UNITARY PLAN UPDATE REQUEST MEMORANDUM

TO Warren MacLennan, Manager Planning North West and Islands
FROM Jo Hart, Principal Planner, Planning North West and Islands
DATE 18 October 2019
SUBJECT **Designation in accordance with s168 of the Resource Management Act of the Auckland Unitary Plan(AUP) Operative in part (15 November 2016)**

CONSENT ORDER

Annexure D – Proposed Temporary Traffic Management Plan (Ref. L1N171201)

Annexure A: Land Requirement Plan - 311/313 Lincoln Road (80507651-0301-C706 Rev B and 80507651-0301-C705 Rev B)

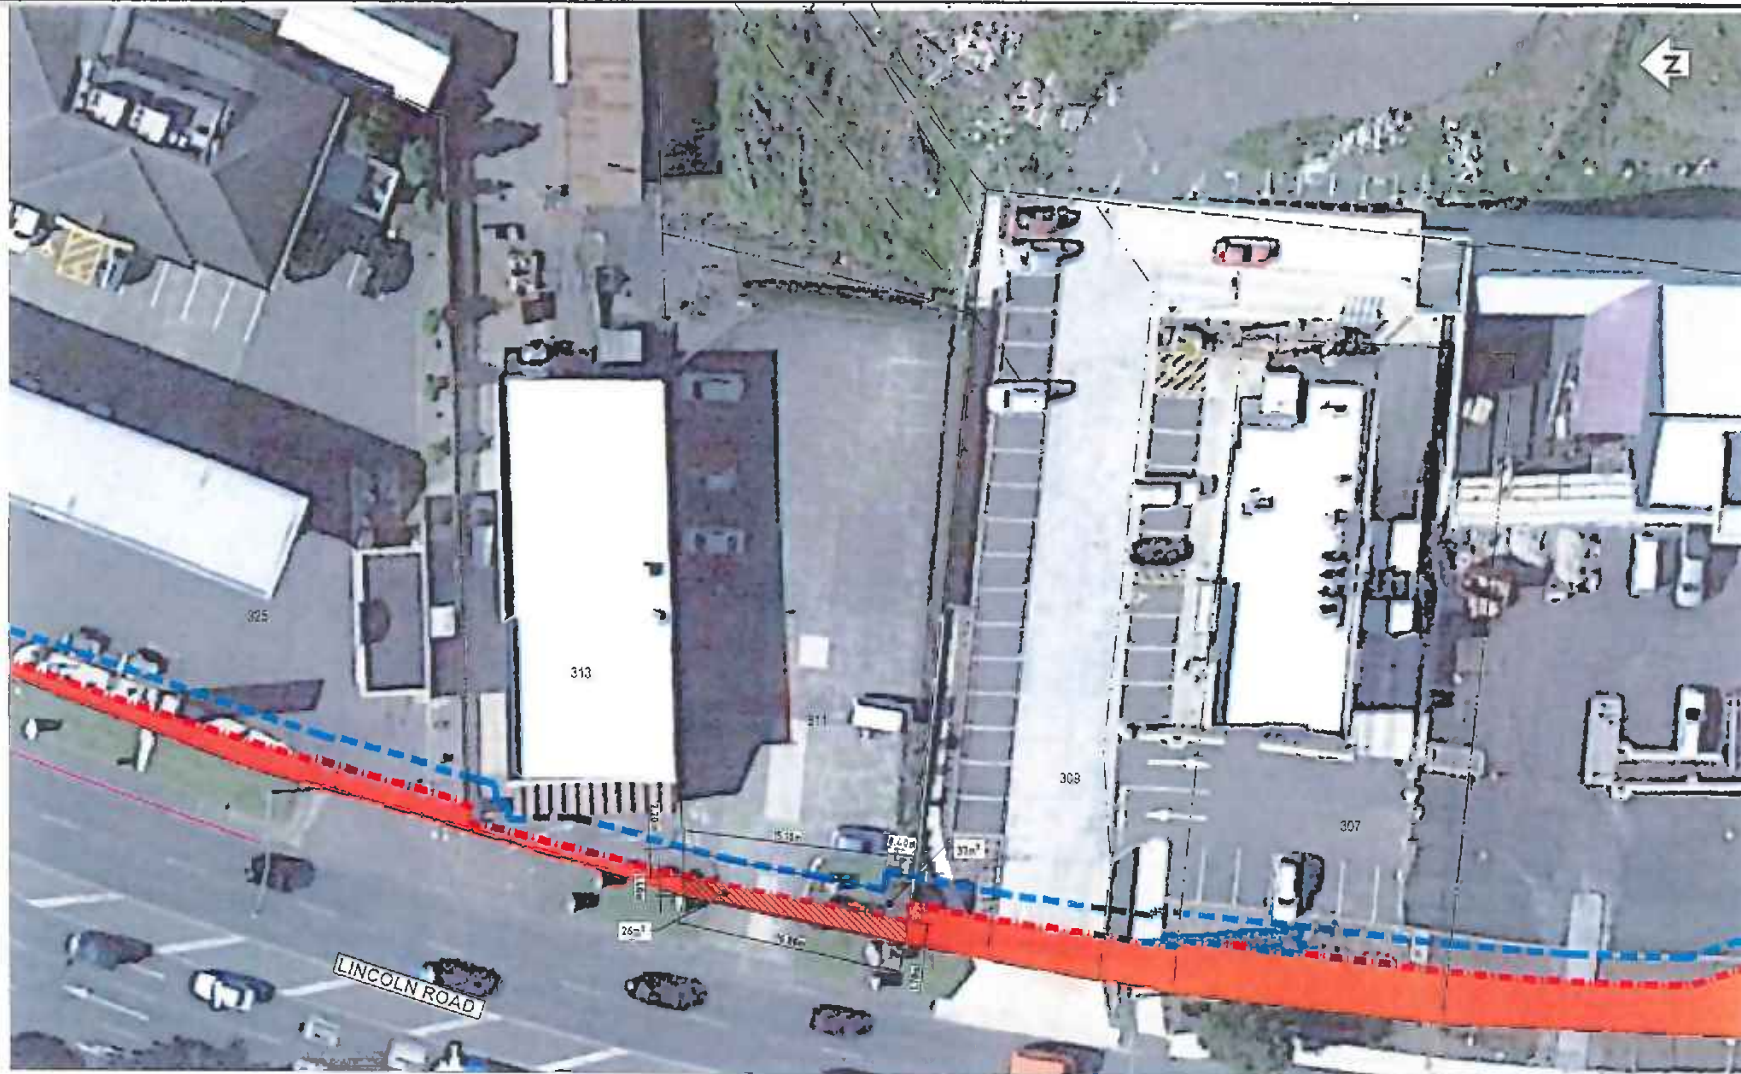
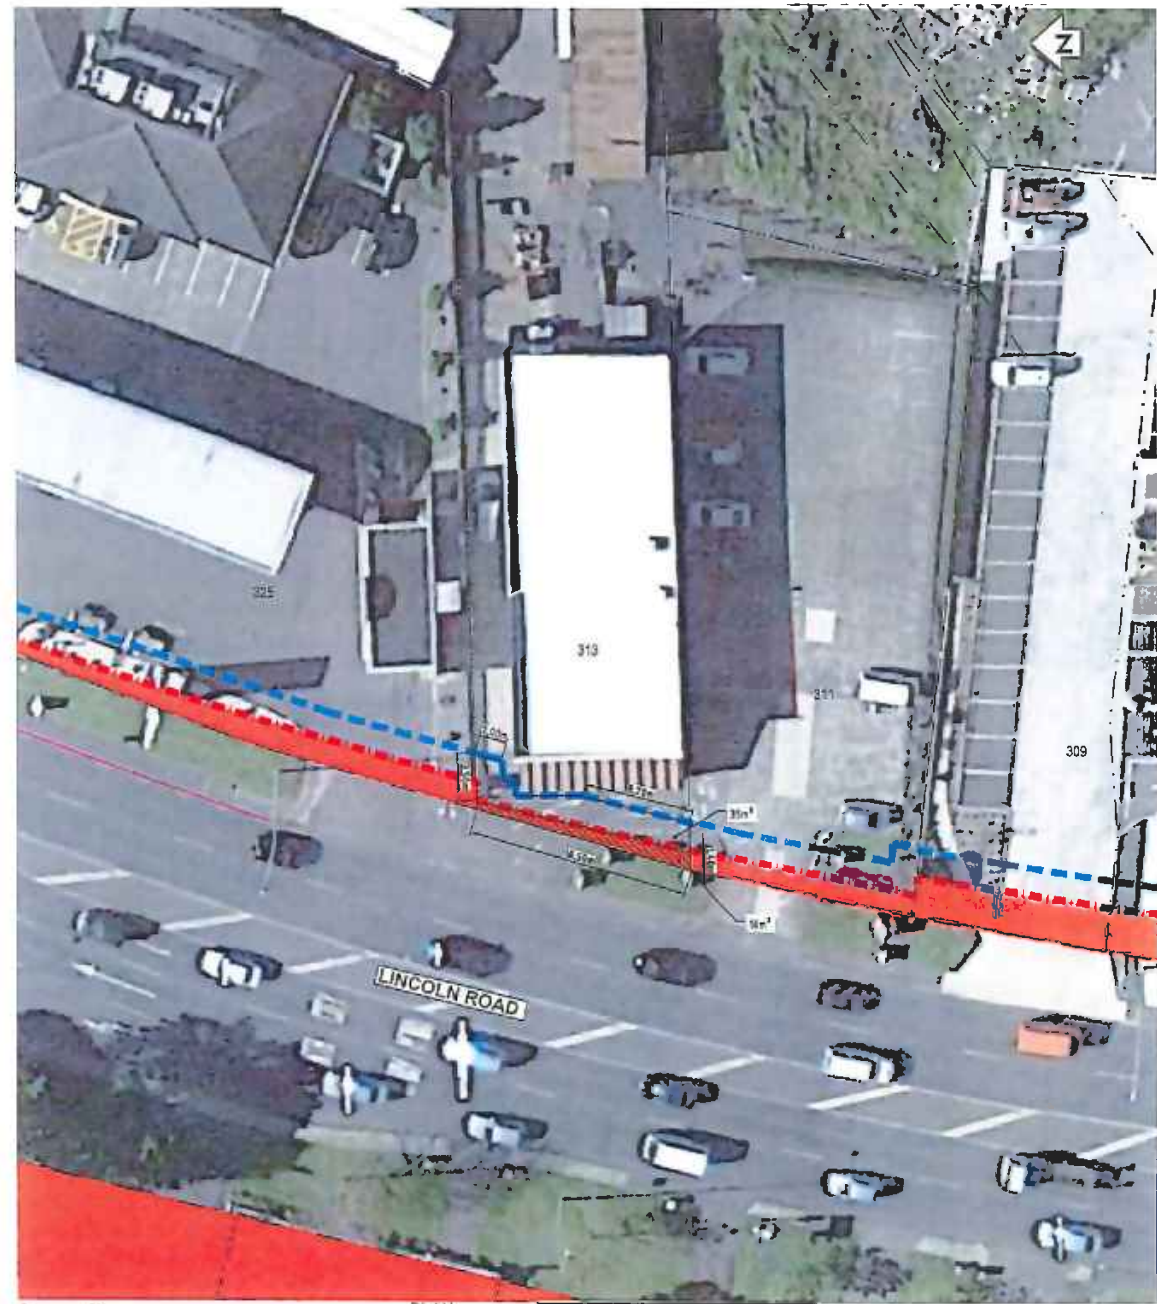
- (a) The appeals are allowed to the extent that the Respondent is directed to reduce the extent of the designation adjacent to 311-313 Lincoln Road as shown in the drawing in **Annexure A**;
- (b) The appeals are allowed to the extent that the Respondent is directed to construct the accessway into and out of 311-313 Lincoln Road in general accordance with **Annexure B**; and
- (c) The appeals are allowed to the extent that the Respondent is directed to make the amendments to the designation conditions as specified in **Annexure C**.
- (d) The appeals are allowed to the extent that the Respondent is directed to revise the accessway arrangements into and out of the National Trading Company's site during the construction of the Project as shown in **Annexure D**.
- (e) The appeals are otherwise dismissed.
- (f) There is no order for costs.

Annexure B: Access arrangement for 311/313 Lincoln Road (80507651-0301-SK004 Rev F)

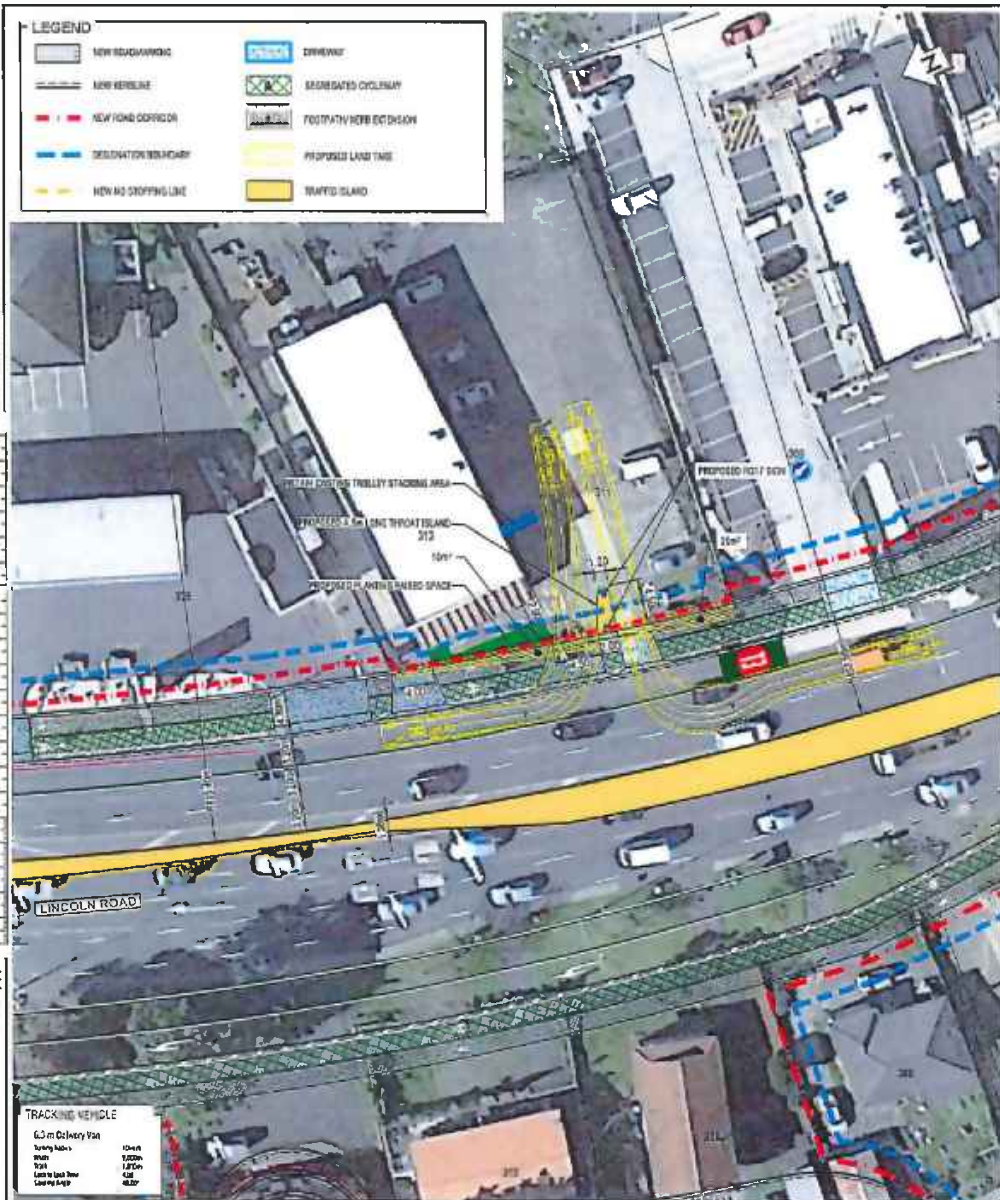
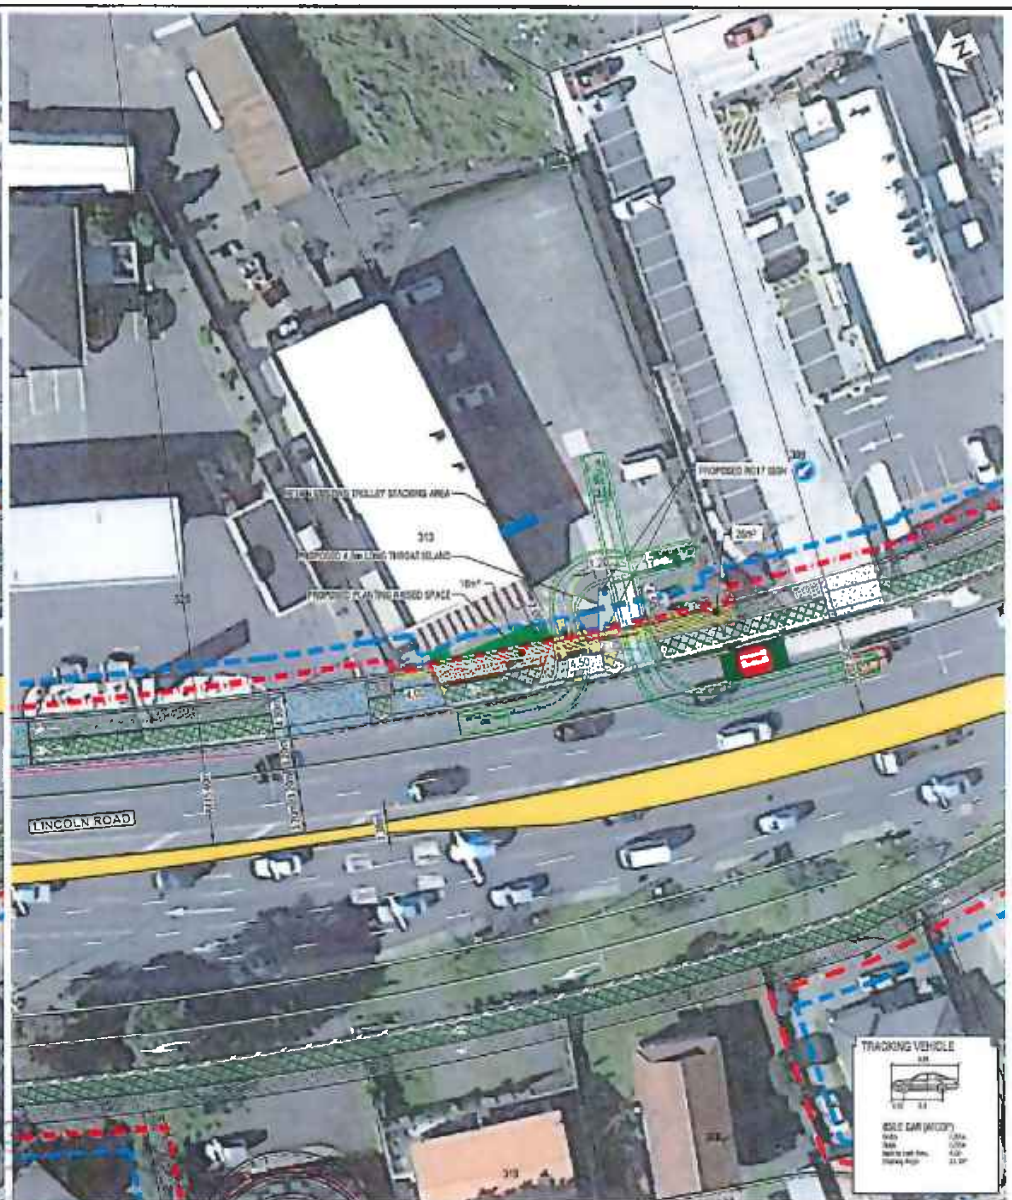
[7] The parties to the National Trading Company's appeal have agreed that the respondent is to revise the accessway arrangements into and out of the National Trading Company's site during the construction of the Project.
